BAR Meeting
July 20, 2016

ISSUE: Partial Demolition/Capsulation and Certificate of Appropriateness for Addition and Alterations

LOCATION: 106 Quay Street

BAR2016-00188 & BAR2016-00189

PROPOSED ROOF PLAN

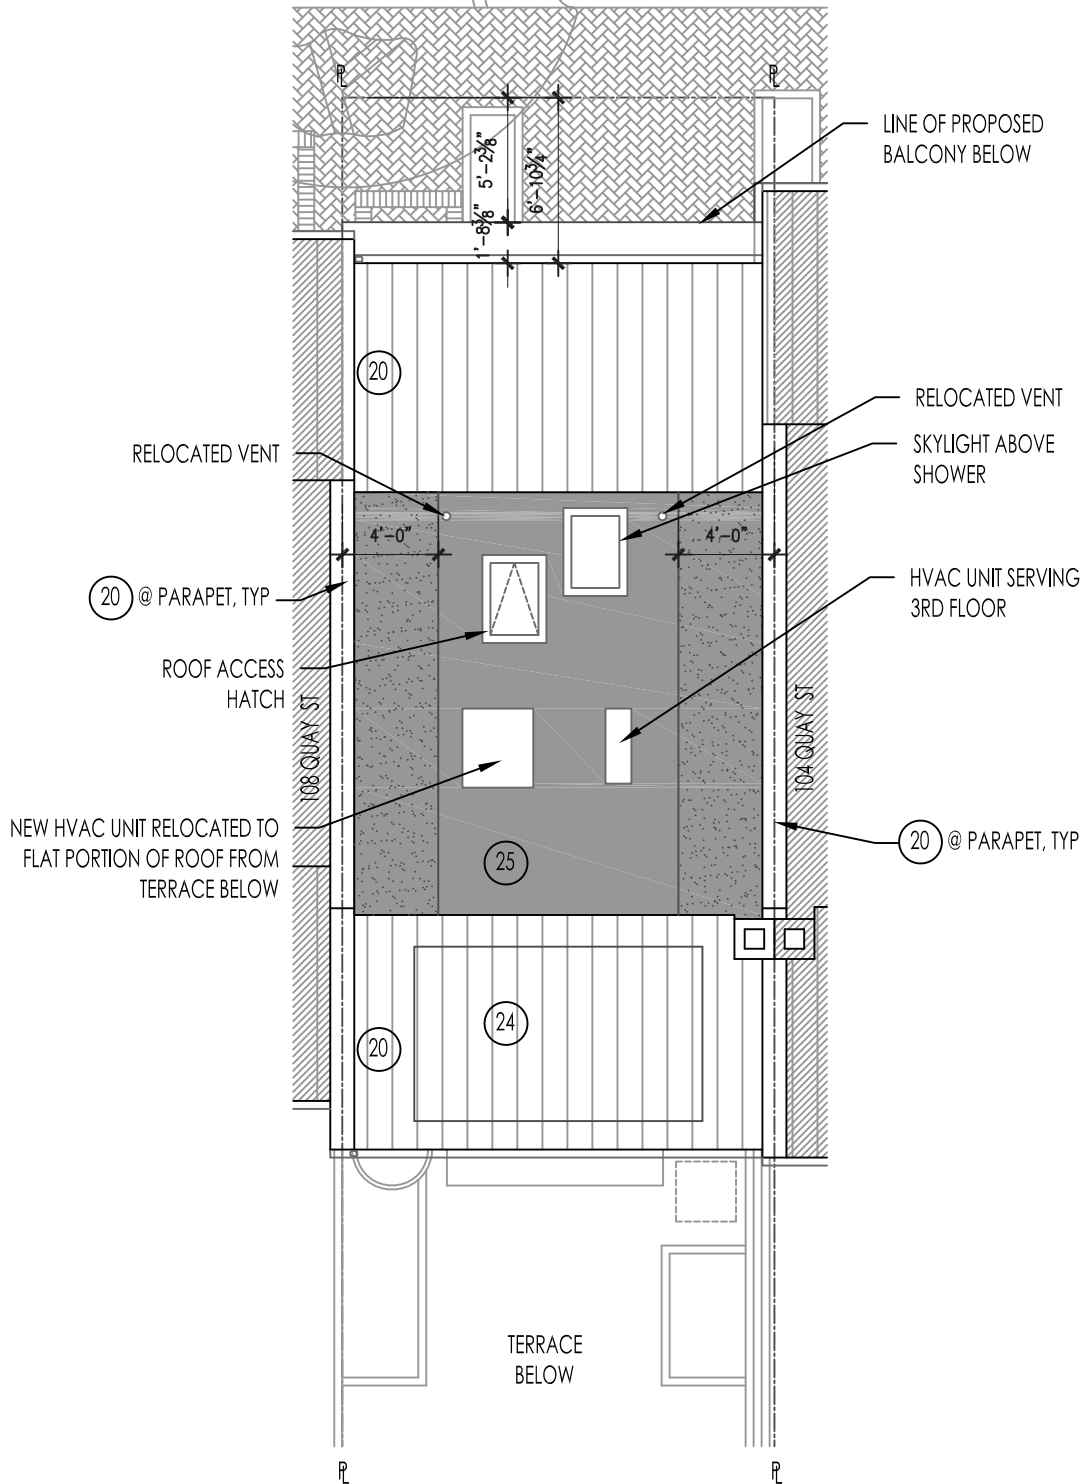
Staff recommends approval of the waiver of the rooftop HVAC screening finding that it will be located so as to be minimally visible.

- C-1 Applicant must request waiver of HVAC screening for new unit to be located on flat roof. If waiver is not granted, Zoning will require screening on all four sides.
